# March 2019 Technical Standards Update

# EP107 – In line Voltage Regulator Assembly

# GS021 & GS201– Underground LV Mains & Service – Pits & Pillars

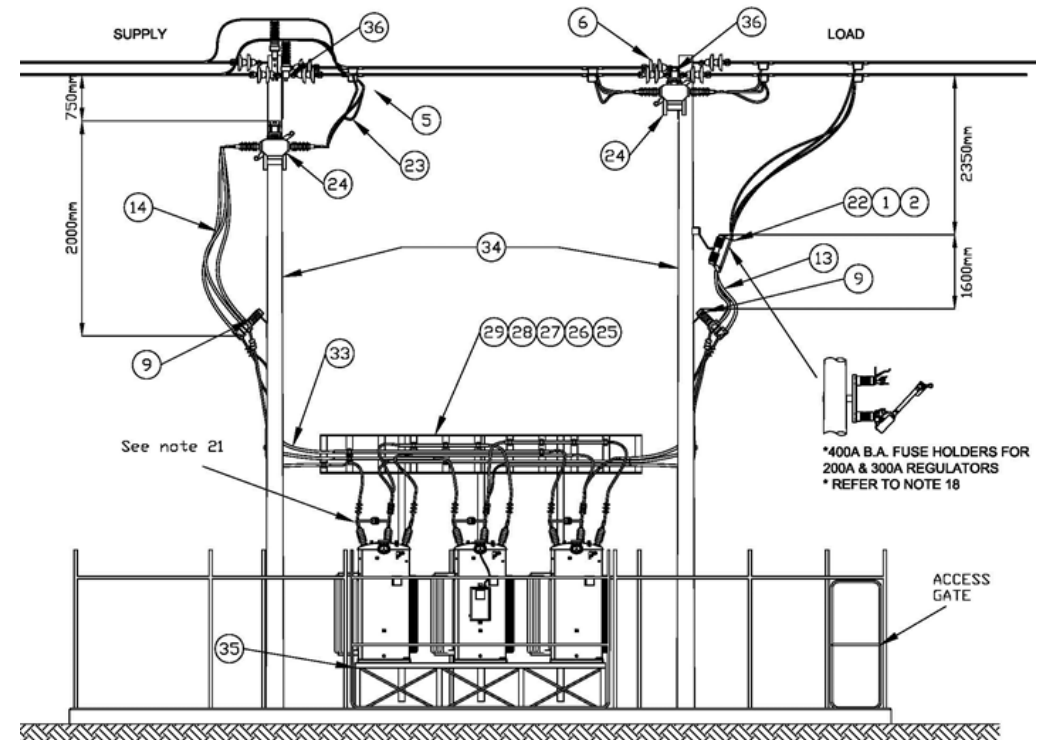
- Technical Standard EP107 has been updated based on design and field resources feedback
- The standard has been updated to include:
  - Additional dimension details
  - SAP material estimate updates
  - Concrete box culverts replaced with steel frame stand for 100A, 200A & 300A regulators
  - Additional earthing connection details

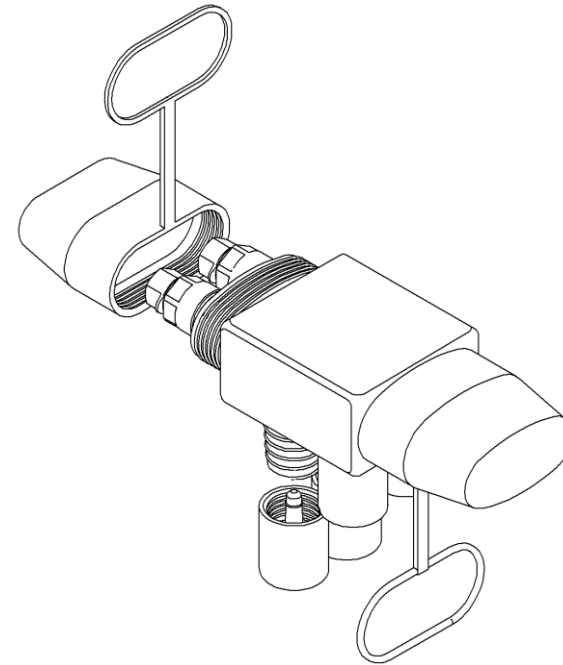
- Technical Standard GS021 has been updated to require the use of 4 by 4 port pit connectors in service pits within industrial areas.
- This change will eliminate the need to interrupt the supply of an existing 3Ø customer when adding a new 3Ø customer.
- The interruption currently occurs while the connectors are changed from 3 by 2 port pit connectors to 4 by 4 port pit connectors. Using 4 by 4 port pit connectors at the initial installation stage will resolve this issue.
